CALL NO. 101  
CONTRACT ID NO. 111313  
ADDENDUM # 1

Subject: Jefferson County, HPP 0163 (032)  
Letting April 22, 2011

**The Parklands of Floyds Fork - Project 2A**  
 Backley Creek Park - North  
 Louisville, Kentucky

MODIFICATIONS TO CONTRACT DOCUMENTS:

Drawing Title:  
**WALL 6  
LAYOUT &  
DETAILS**  
 Drawing No:  
**SW-6001**

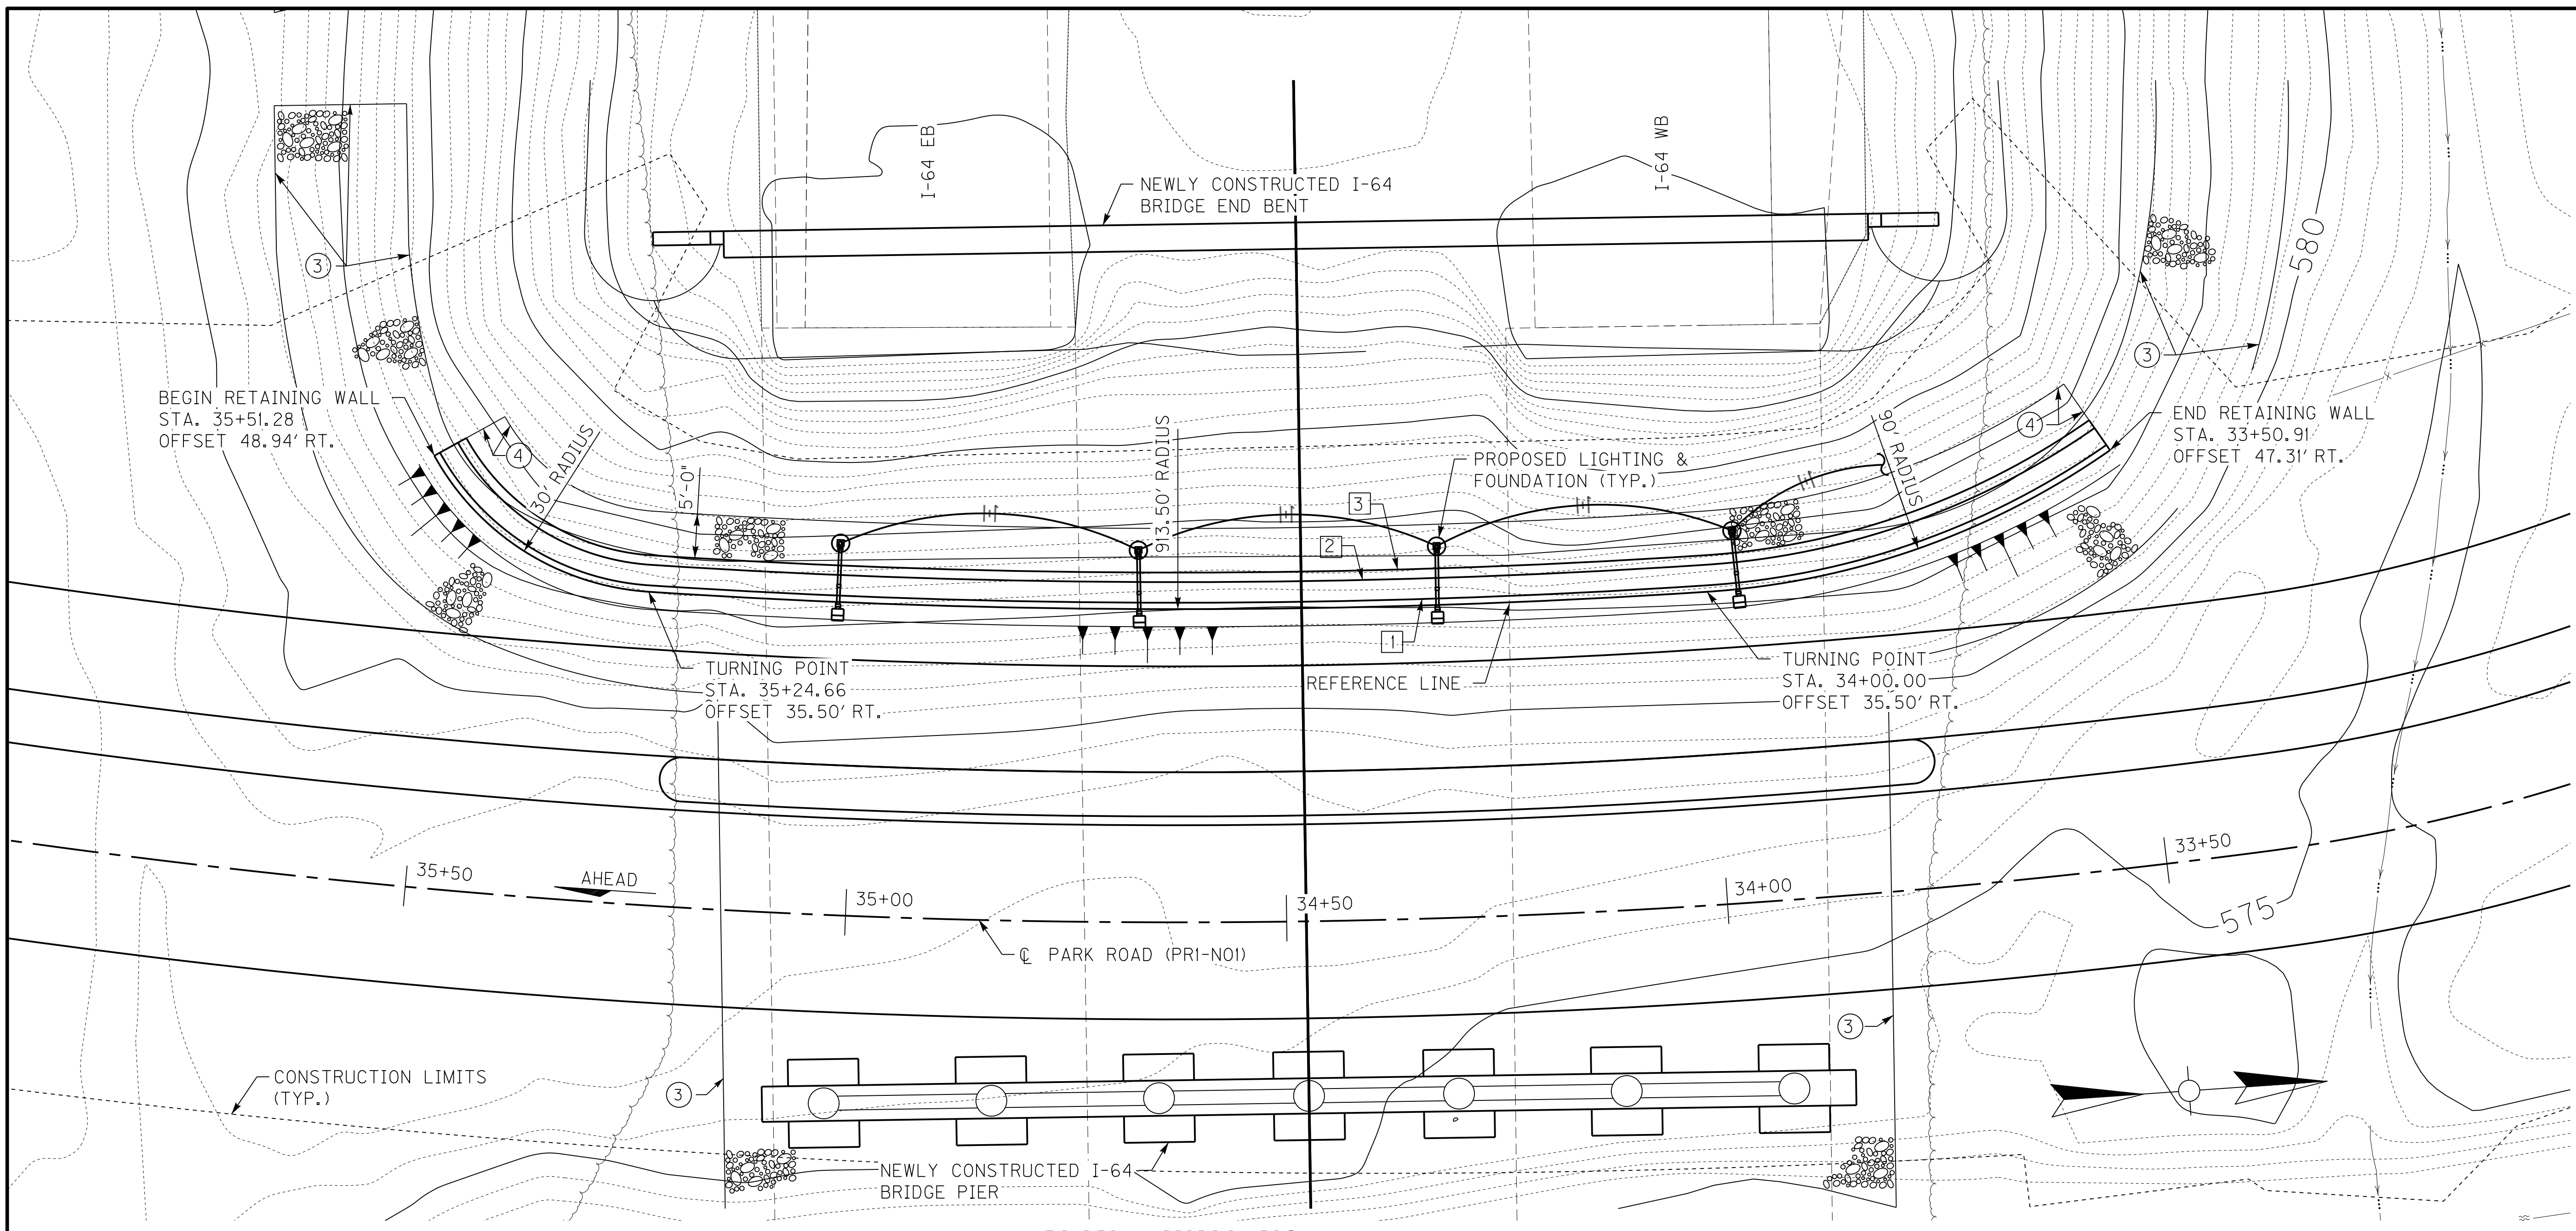
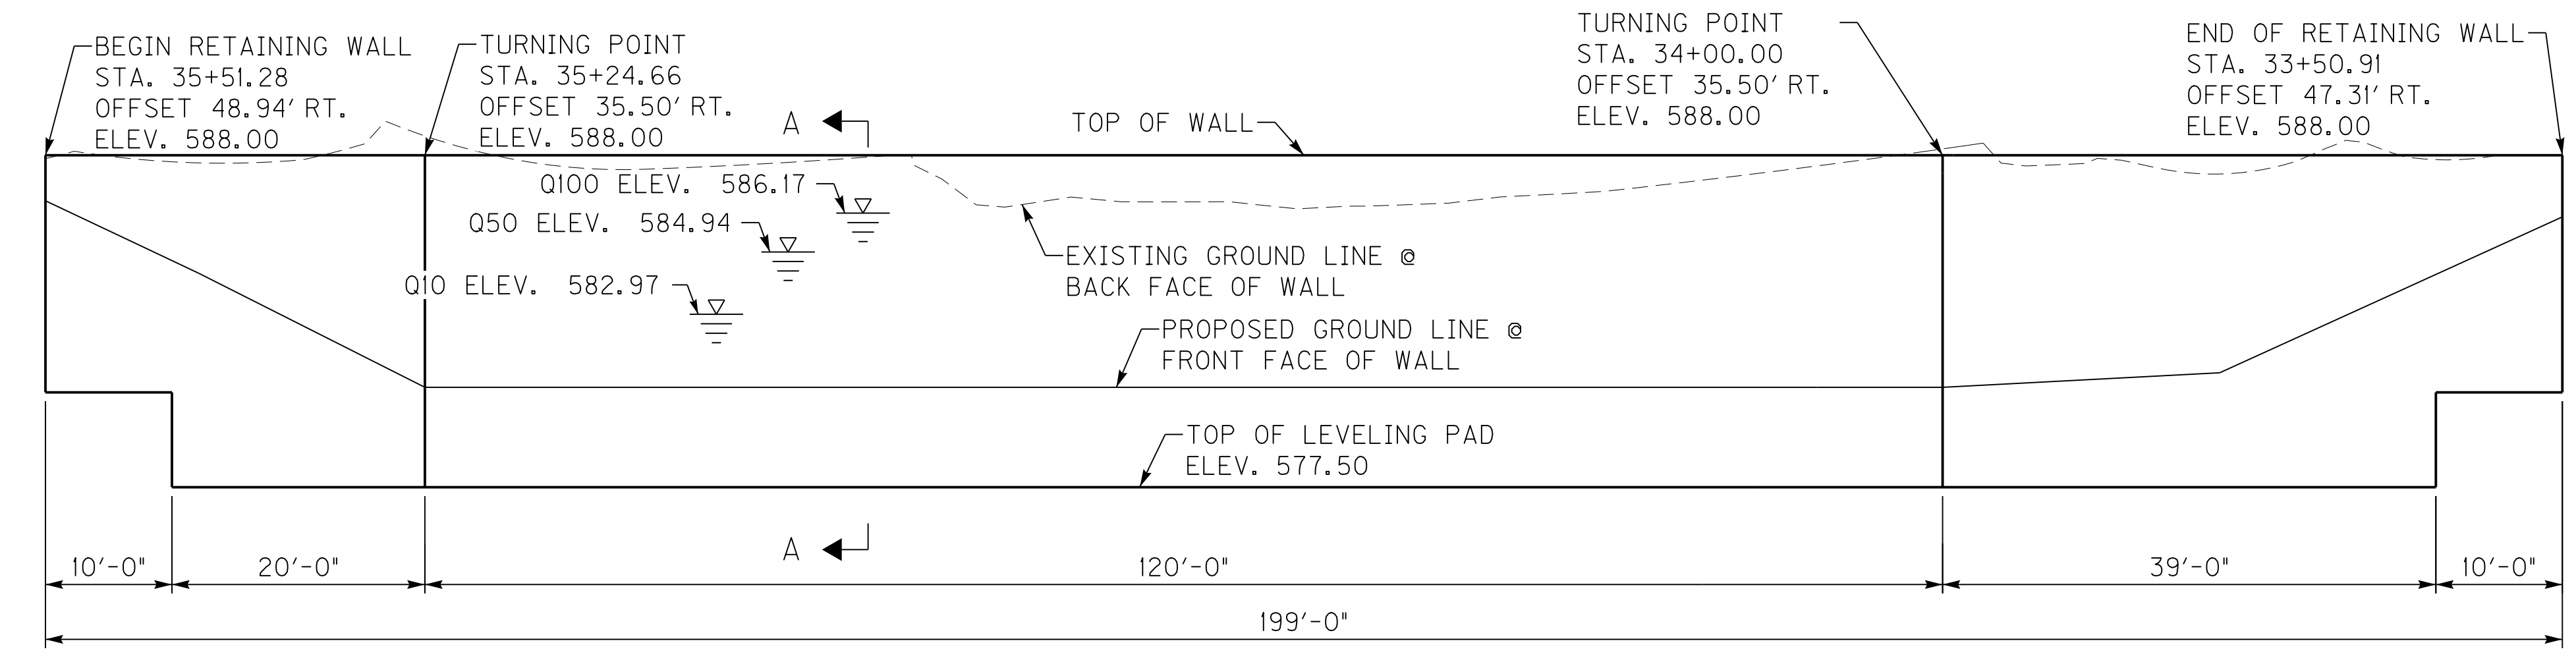
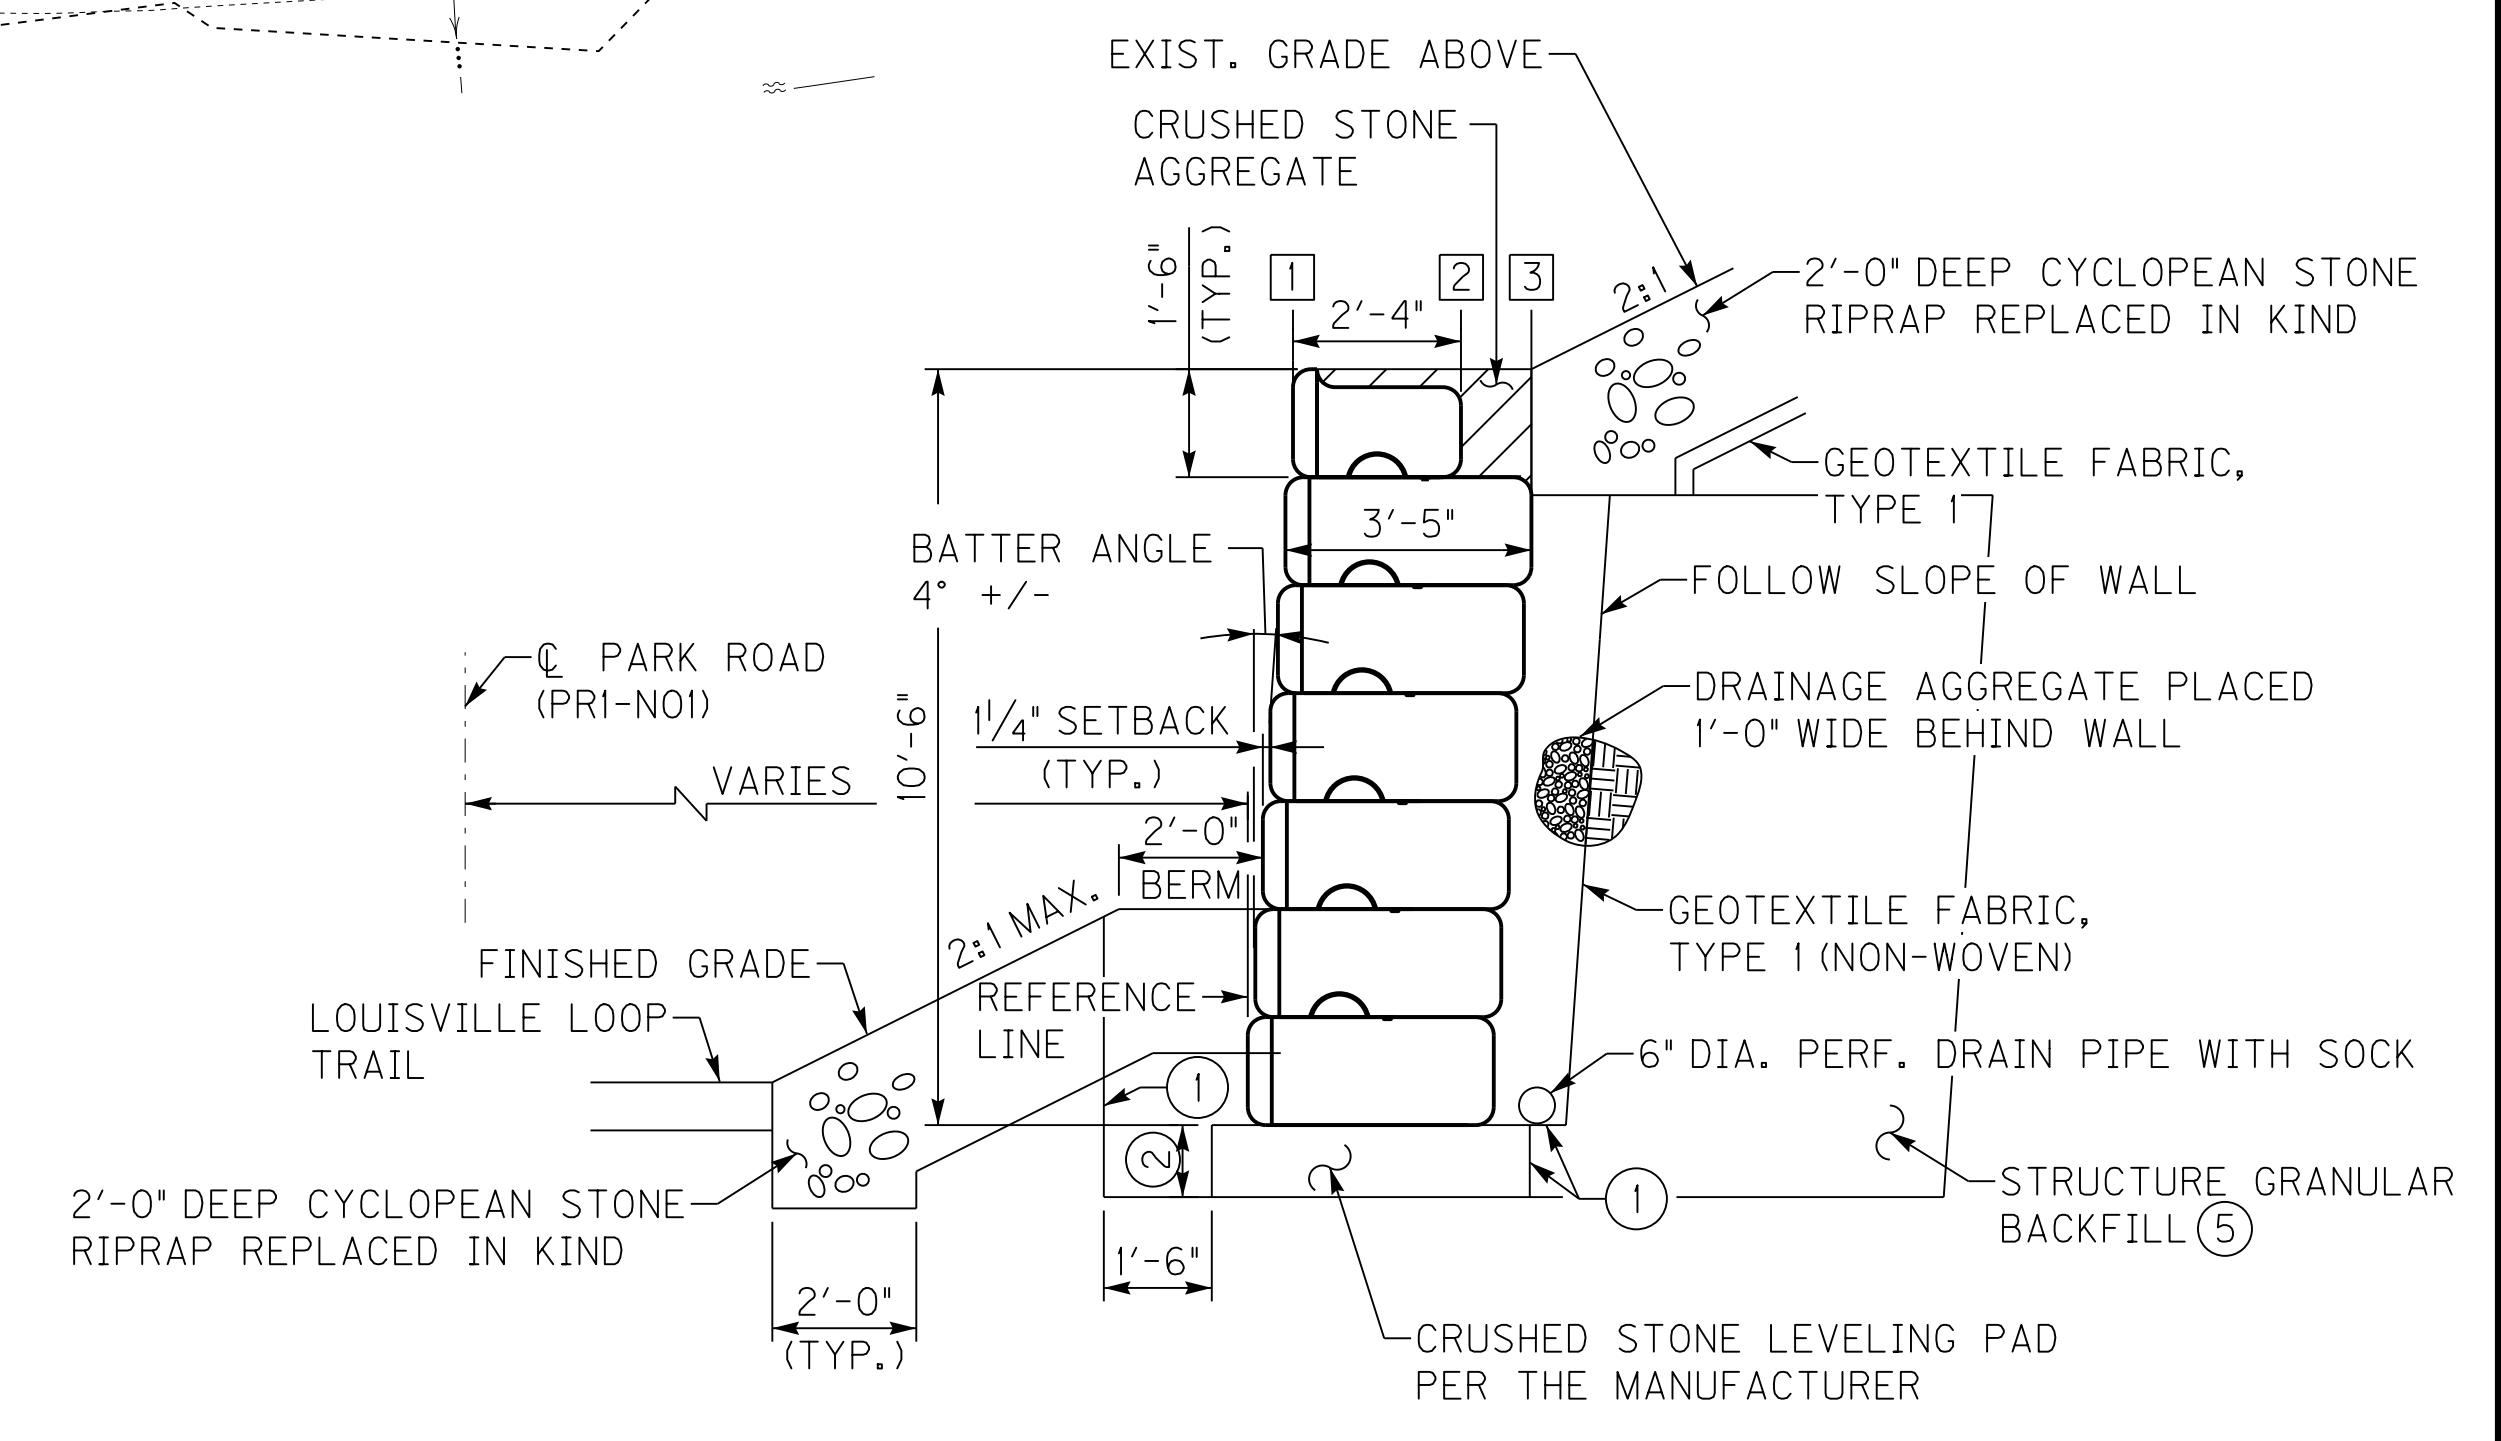
- SW-1001 Revised note to read “The wall block system shall be the Ledgestone series with color scheme “Kentuckiana Buff” as manufactured by Redi-Rock of Kentuckiana, Mt. Washington, KY., or approved equal.
- SW-2001 Revised note to read “The wall block system shall be the Ledgestone series with color scheme “Kentuckiana Buff” as manufactured by Redi-Rock of Kentuckiana, Mt. Washington, KY., or approved equal.
- SW-3001 Revised note to read “The wall block system shall be the Ledgestone series with color scheme “Kentuckiana Buff” as manufactured by Redi-Rock of Kentuckiana, Mt. Washington, KY., or approved equal.
- SW-6001 Revised note to read “The wall block system shall be the Ledgestone series with color scheme “Kentuckiana Buff” as manufactured by Redi-Rock of Kentuckiana, Mt. Washington, KY., or approved equal.

- THE WALL BLOCK SYSTEM SHALL BE THE LEDGESTONE SERIES WITH COLOR SCHEME 'KENTUCKIANA BUFF' AS MANUFACTURED BY REDI-ROCK OF KENTUCKIANA, MT. WASHINGTON, KY., OR APPROVED EQUAL.
